QUINCY PRESERVATION COMMISSION
 706 MAINE STREET, 3RD FLOOR, CITY HALL ANNEX
 QUINCY, ILLINOIS 62301
 217-228-4515

CERTIFICATE OF APPROPRIATENESS APPLICATION

Name and Street Address of Property Issac and Ellen Lessem House
1449 Maine Street Quincy, IL 62301

December 2010 Certificate of Appropriateness

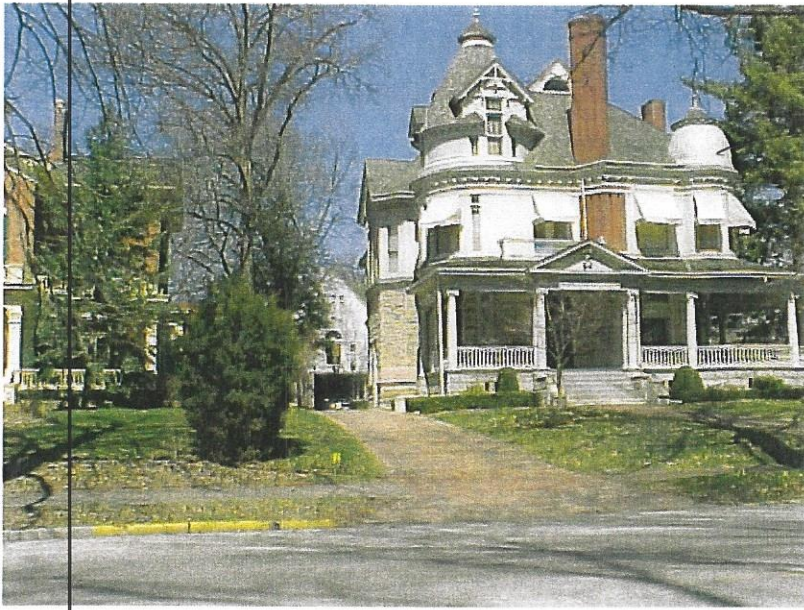
suggest - specific
 proposal.
 committee would like
 to see a
 sample
 we
 cannot
 do the
 whole
 roof
 done
 neither

can committee
 meet with this
 as soon as
 possible

— painted,

I am writing to confirm that the Certificate of Appropriateness Committee of the Quincy Preservation Commission has voted by phone and e-mail to approve your C of A application to replace the cedar roofing shingles on the Issac and Ellen Lesem House, 1449 Maine Street, with architectural asphalt shingles.

The shingles to be replaced are located on the main roof, the front porch roof, the roofs of the southwest tower and the southeast turret (with the exception of the painted cedar shingles on the southeast turret), and on the projecting shingle band between the first and second story.
